# Wisconsin Department of Transportation

**Proposal #02: 4150-26-71, WISC 2024378**  
**Mid Junction – Baileys Harbor**  
**STH 42 – Summit Road**  
**STH 57**  
**Door County**

This is Addendum No. 01, which provides for the following:

**ADDENDUM NO. 01**

Addendum No. 01  
 ID 4150-26-71  
 Revised Sheet 196  
 July 18, 2024

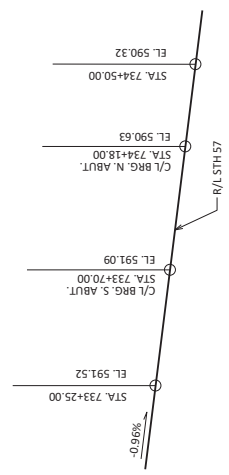
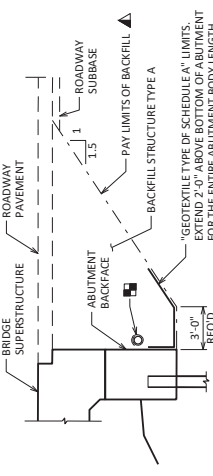
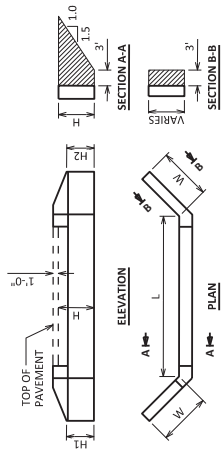
<b>Revised Plan Sheets</b>	
Plan Sheet	Plan Sheet Title (brief description of changes to sheet)
67	Miscellaneous Quantities (revised item quantities and adding items for providing different seed mixtures)
77	Miscellaneous Quantities (adding mowing item)
196	Structure B-15-30 (revised item quantity)
